**PROPOSED REVISION 15**  
**AP1000 DESIGN CONTROL DOCUMENT**

**Tier 1 Subsection 2.1.2; Tables 2.1.2-1 through 2.1.2-4; and Figures 2.1.2-1 and 2.1.2-2**  
**Reactor Coolant System**

**Description of Change**

**Figure 2.1.2-1 (Sheet 1 of 2)**  
**Reactor Coolant System**

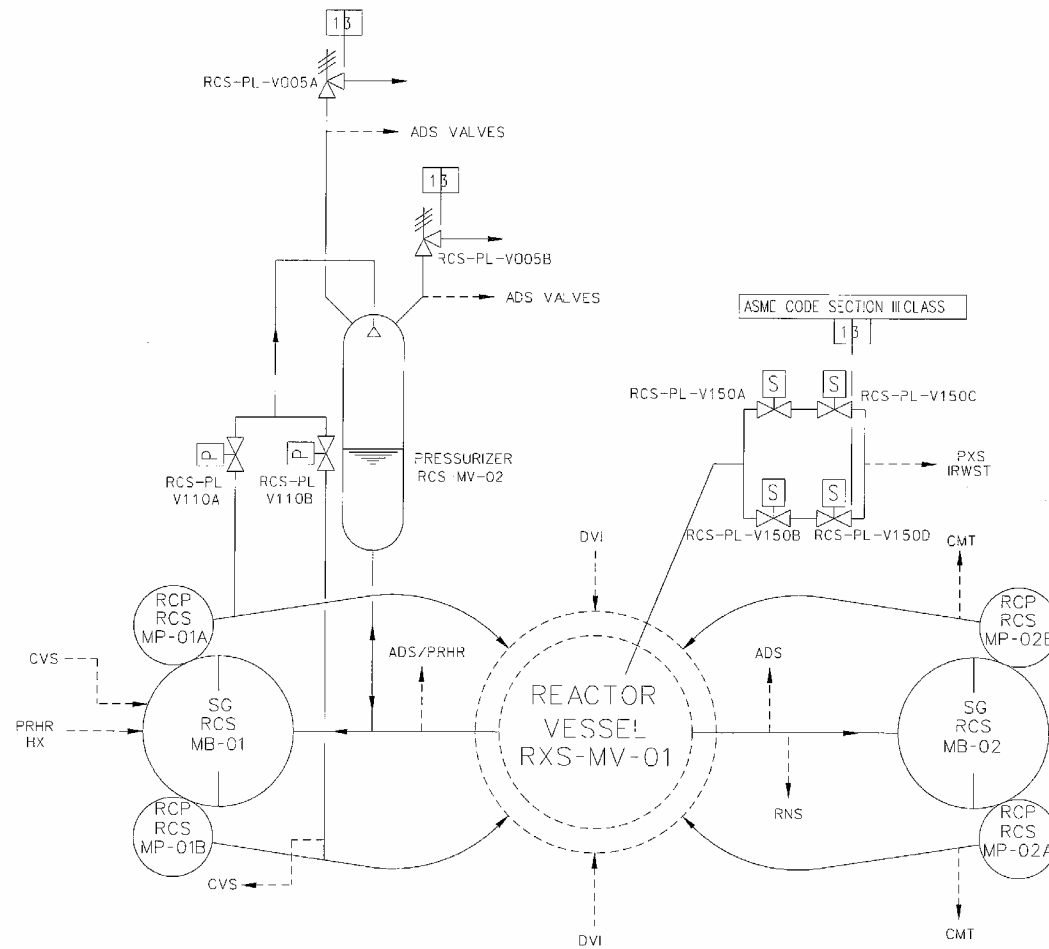
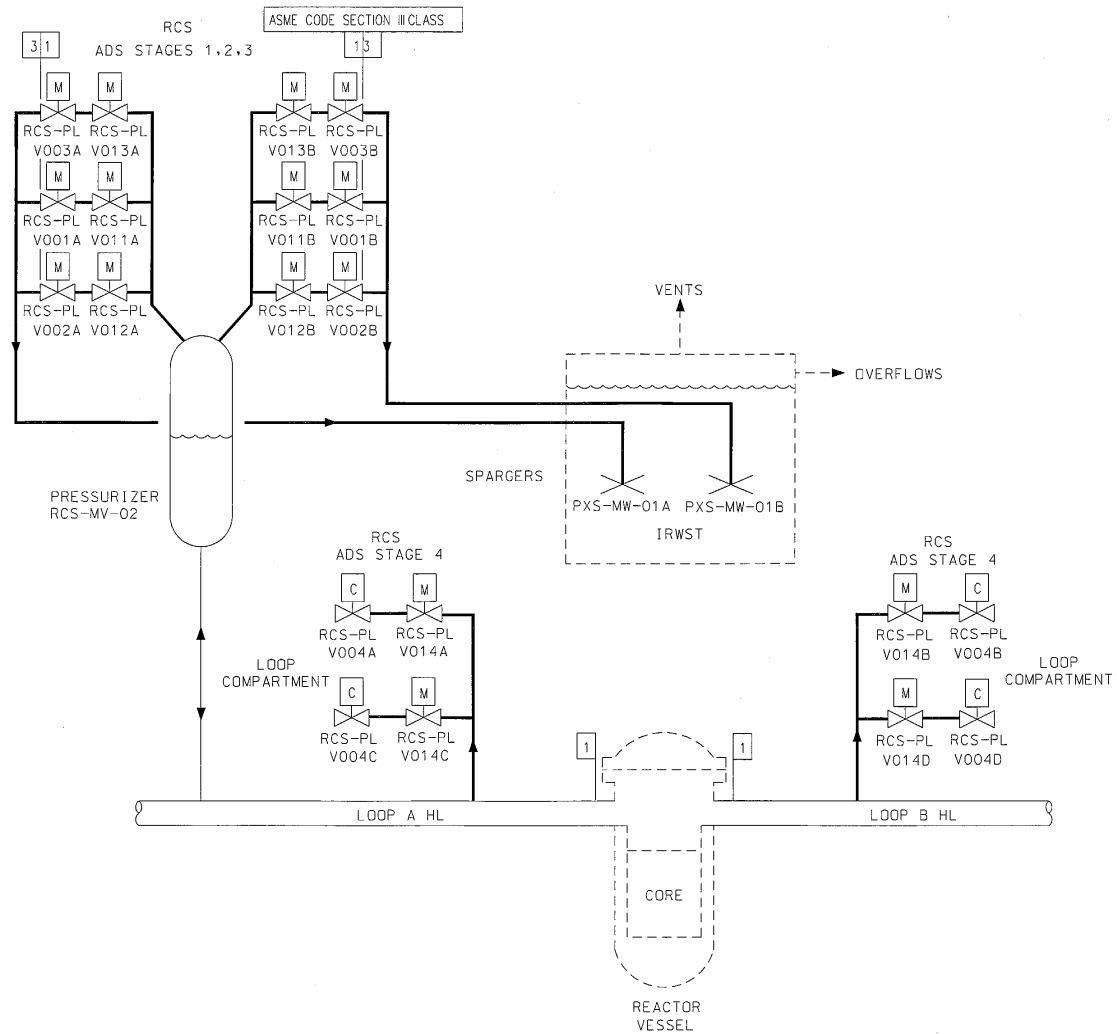
**Tier 1 Figure 2.1.2-1** Revise Figure 2.1.2-1 as follows:

**Figure 2.1.2-2**  
**Flow Transient for Four Cold Legs**  
**in Operation, Four Pumps Coasting Down**

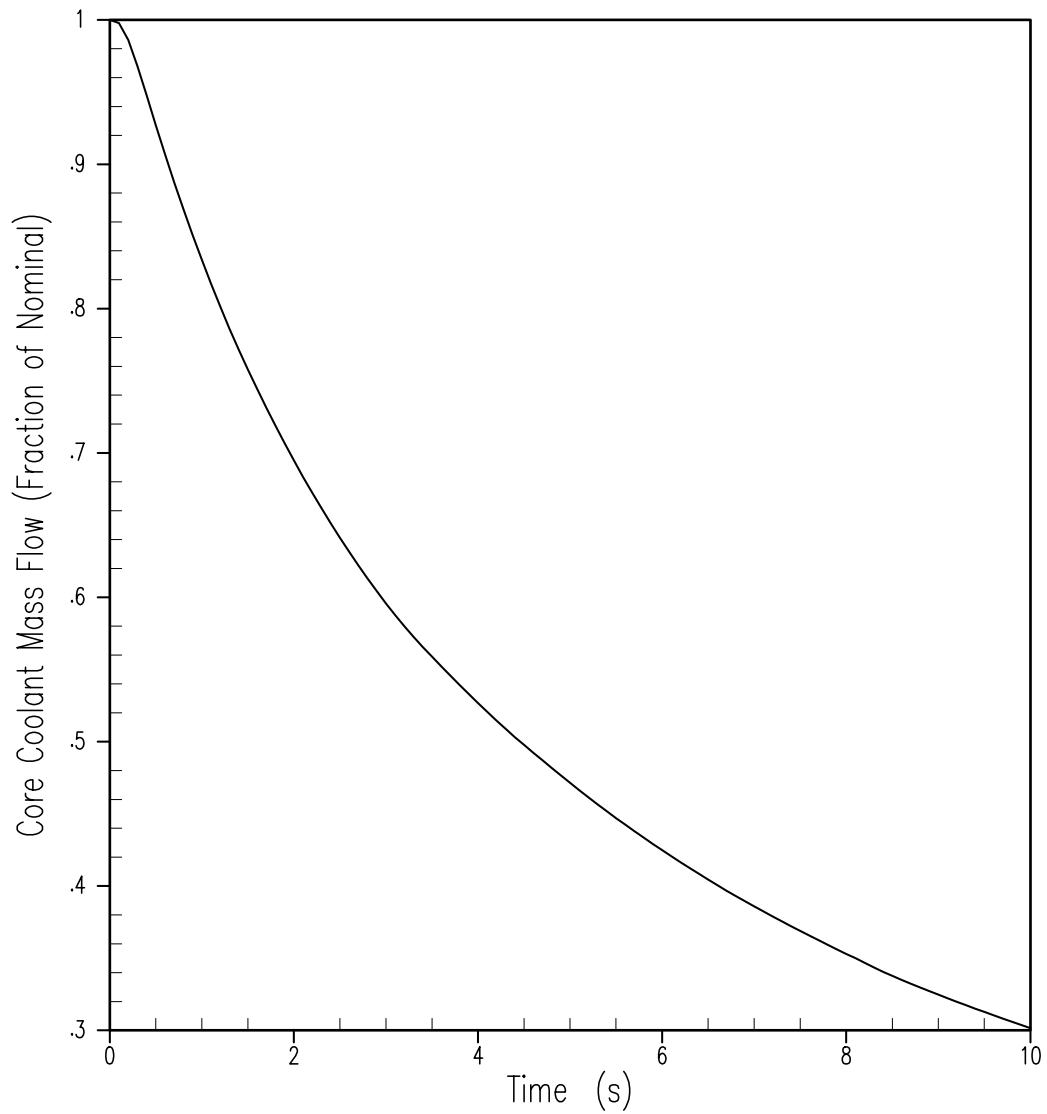
A pump coastdown curve is added since the specified inertia does not guarantee that the pump coastdown will be achieved sufficient to satisfy the safety analyses without knowing the pump resistances.

8.b) The RCPs have a rotating inertia to provide RCS flow coastdown on loss of power to the pumps.	<u>Inspection of as-built RCP vendor data will be performed. A test will be performed to determine the pump flow coastdown curve.</u>	<u>The calculated rotating inertia of each RCP is no less than 46,500 lb-ft<sup>2</sup>. The pump flow coastdown will provide RCS flows greater than or equal to the flow shown in Figure 2.1.2-2, "Flow Transient for Four Cold Legs in Operation, Four Pumps Coasting Down."</u>

**Tier 1 Figure 2.1.2-2** Add Figure 2.1.2-2 as follows:
